# Groundwater Application Review Summary Form

Application # G- 19250

GW Reviewer Grayson Fish Date Review Completed: 3/5/2026

PUBLIC INTEREST REVIEW FOR GROUNDWATER APPLICATIONS

### Water-Level Measurements in Nearby Wells

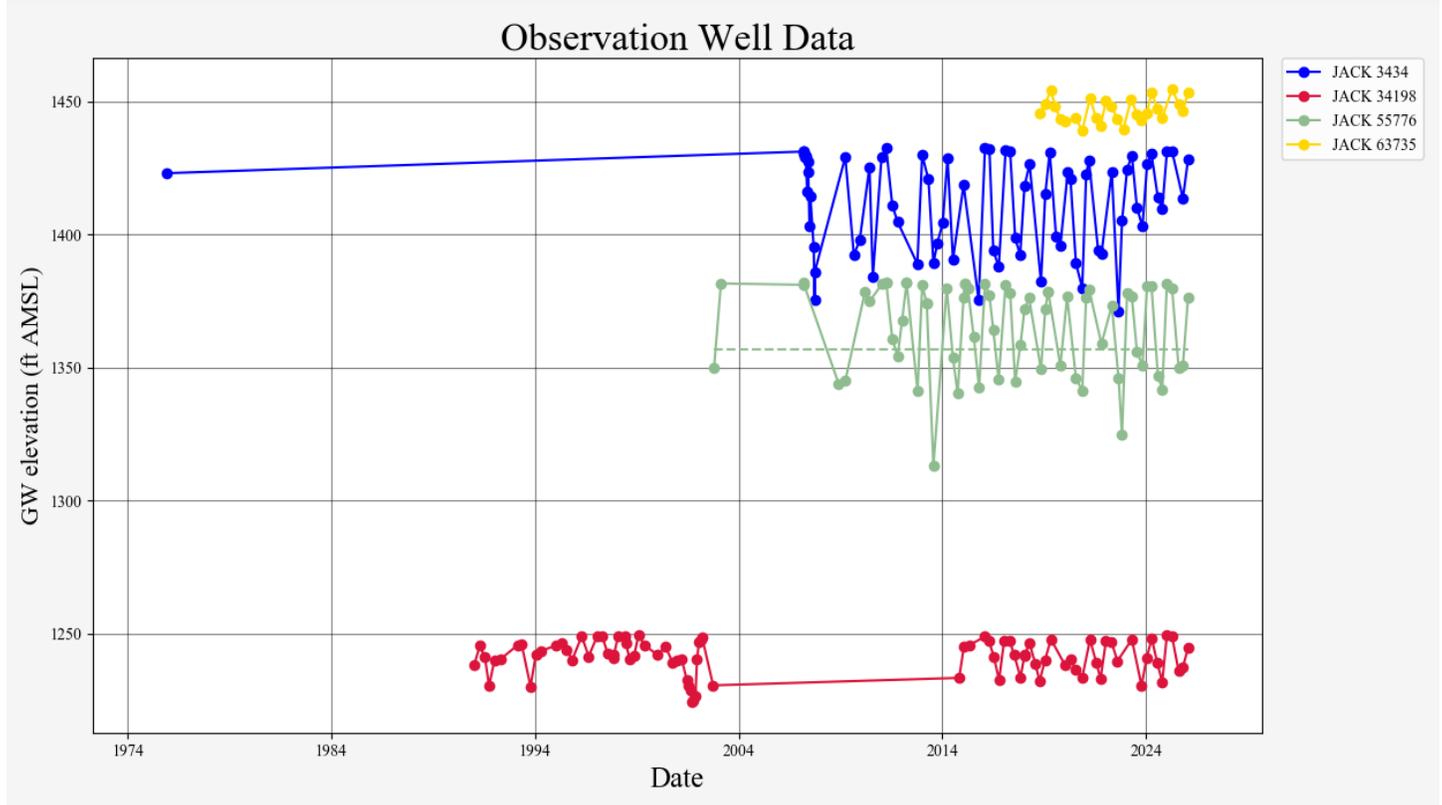
The available water level record from wells located to the north of the proposed location which also source water from the Payne Cliffs formation do not meet the Division 8 definition of excessively declining or declined excessively for the storage portion of the source of water to wells. Given the available information, a preponderance of evidence does not exist to find that groundwater is over appropriated in the aquifer to be accessed.
